**CONSTRUCTION BULLETIN
No. 002**

**Institution: California Institution for Men (CIM)
Project Name: Replace Roofs Phase 1
Construction Bulletin Number: 002
Date of Issuance: February 6, 2026**

Description: This Bulletin makes modifications and corrections to the Project Manual and Drawings as described below.

DATE: 11/03/2025
SHEET NUMBER
A2.5
15 OF 80 SHEETS V1

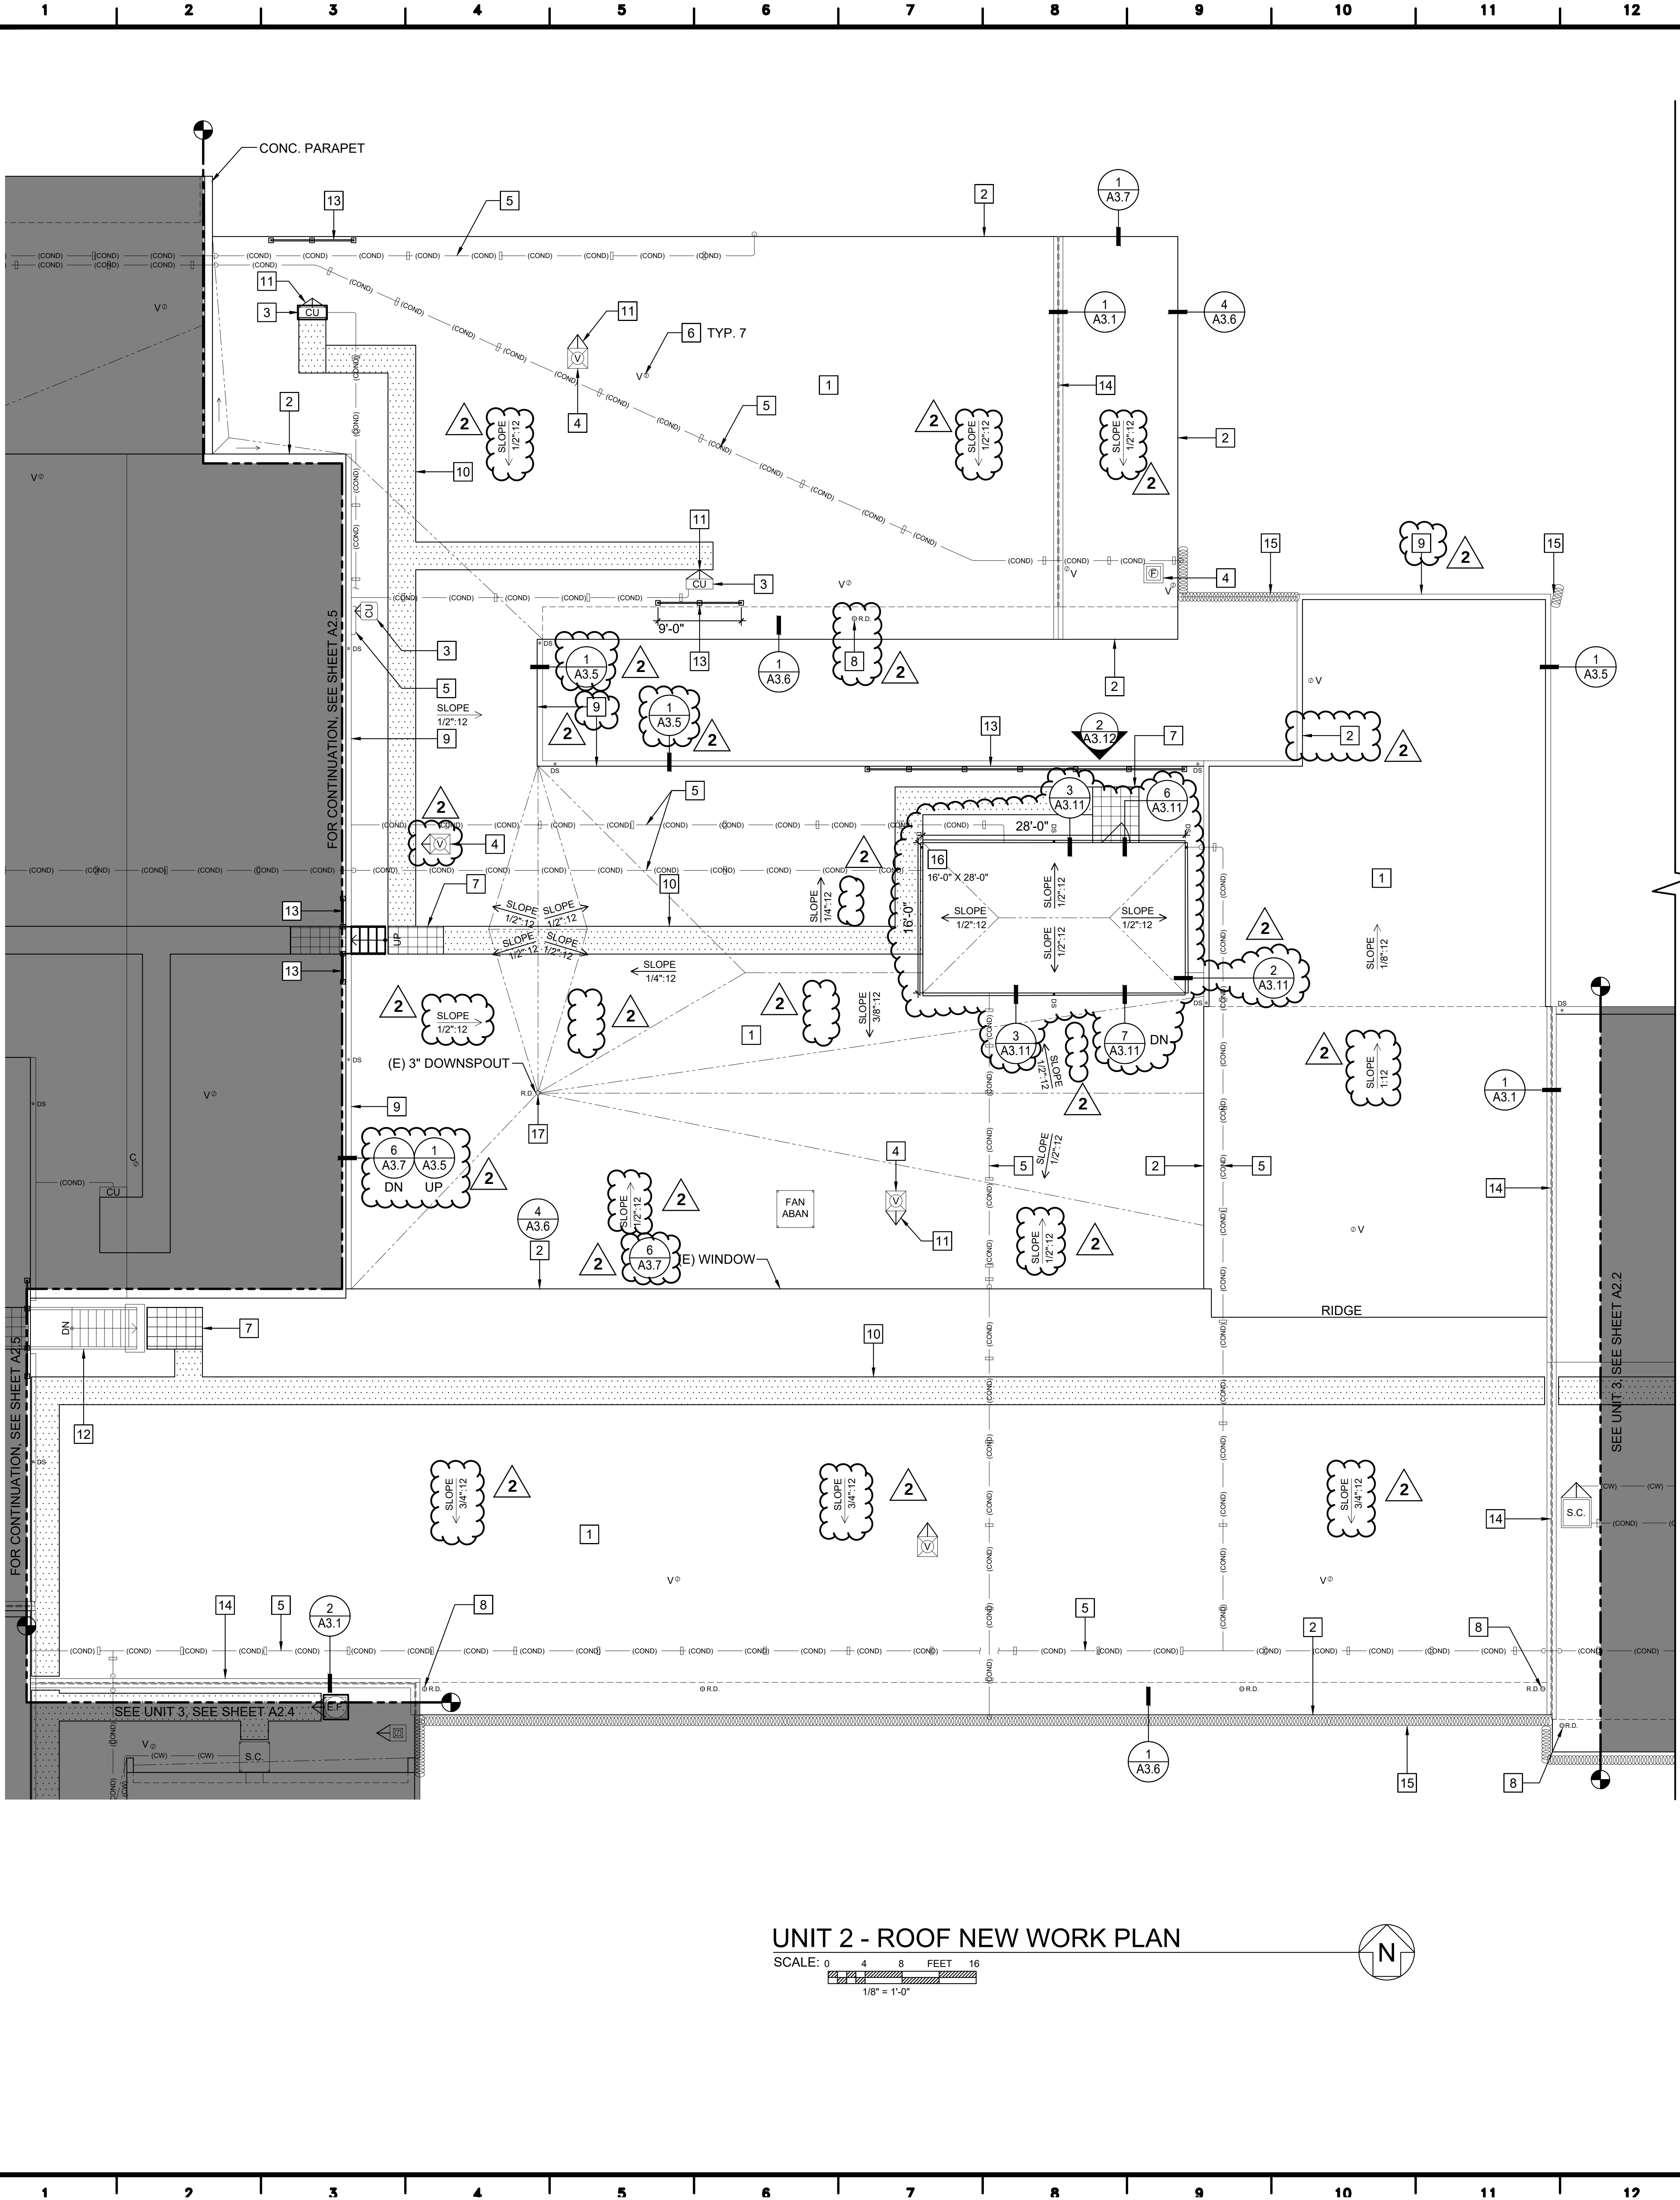
5. Sheet **A2.5 – UNIT 2 –ROOF NEW WORK PLAN**
- a. **Modify** NEW WORK KEYNOTE 10 text from PROVIDE NEW ROOF DRAIN to REINSTALL (E) CAST-IRON DOME STRAINER AT (E) ROOF DRAIN

- b. **Modify** NEW WORK KEYNOTE 18 text from DOWNSPOUT to REINSTALL METAL GUTTER AND DOWNSPOUT, SEE DETAIL 7/A3.7
 - c. **Modify** NEW WORK KEYNOTE 19 text from ROOF SCUPPER AND OVERFLOW to ROOF SCUPPER AND OVERFLOW, SEE DET. 6/A3.6

- d. **Add** NEW WORK KEYNOTE 20 reading PVC ROOFING WITH XPS TAPER INSULATION AT MECHANICAL PENTHOUSE SEE SHEETS A3.11 & A3.1
 - e. **Modify** LEGEND information regarding ELEVATION DATUM

- f. **Add** Mechanical Penthouse roof to scope of work.
 - 1) **Add** roof slopes
 - 2) **Add** dimensions
 - 3) **Add** NEW WORK KEYNOTE tag 20
 - 4) **Add** tag for DETAIL 2/A3.11

- 5) **Add** tag for DETAIL 4/A3.11
 - 6) **Add** tag for DETAIL 6/A3.11
 - 7) **Add** tag for DETAIL 7/A3.11
 - g. **Change** roof slope from 1/4:12 to 1/2:12

- h. **Change** roof slope from 1/4:12 to 1/2:12
 - i. **Change** roof slope from 1/4:12 to 1/2:12
 - j. **Remove** NEW WORK KEYNOTE tag 18
 - k. **Add** roof slope 1/2:12

- l. **Change** tag for DETAIL from 7/A3.7 to 1/A3.5
 - m. **Remove** tag for DETAIL 2/A3.5
 - n. **Modify** cricket direction
 - o. **Remove** roof slope 5/8:12

- ll. **Modify** roof slopes to drain to roof drain and add roof slopes 1:12
 - mm. **Remove** tag for DETAIL 6/A3.6
 - nn. **Remove** roof slope 1/4:12

- oo. **Change** roof slope from 1 1/8:12 to 1:12
 - pp. **Add** roof slope 1:12
 - qq. **Add** roof slope 1:12
 - rr. **Add** roof slope 1:12
 - ss. **Add** roof slope 1:12

- tt. **Add** tag for DETAIL 7/A3.7
 - uu. **Change** tag for DETAIL from 2/A3.6 to 7/A3.7
6. Sheet A2.6 – UNIT 2 –ROOF NEW WORK PLAN
- a. **Add** NEW WORK KEYNOTE 16 reading PVC ROOFING WITH XPS TAPER INSULATION AT MECHANICAL PENTHOUSE SEE SHEETS A3.11 & A3.1
